## Inspection/Audit Photos

Location Name: TEP ROCKY MOUNTAIN LLC CSF 33B-07-07-91 Pad

Location # 335051

**Photo # 6184 From inspection/audit 708906074 conducted on 03/20/2025 Bird protection on separator insufficient /burner stack available for entry by wildlife/wildlife hazard**

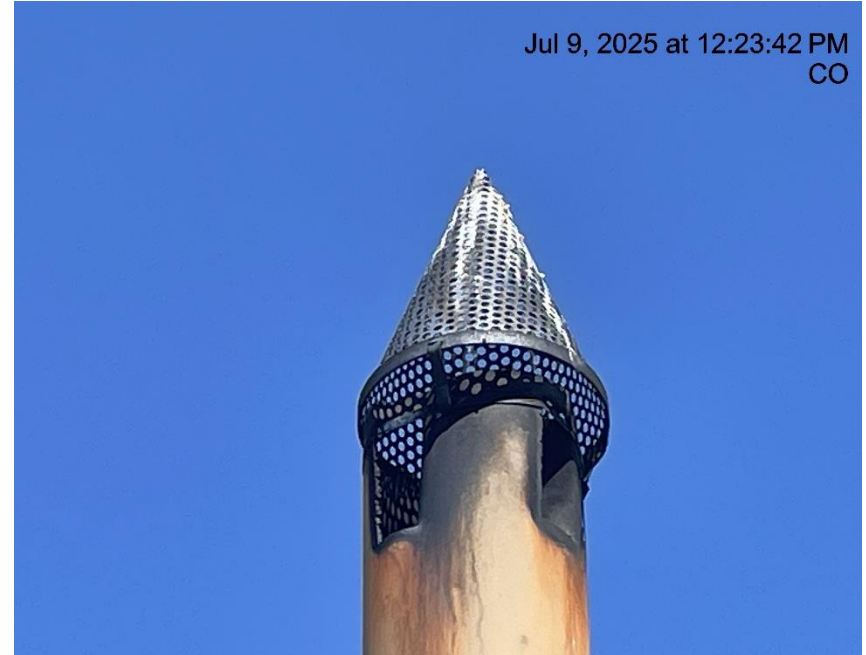
**Photo # 295 Bird protection on separator insufficient /burner stack available for entry by wildlife/wildlife hazard**
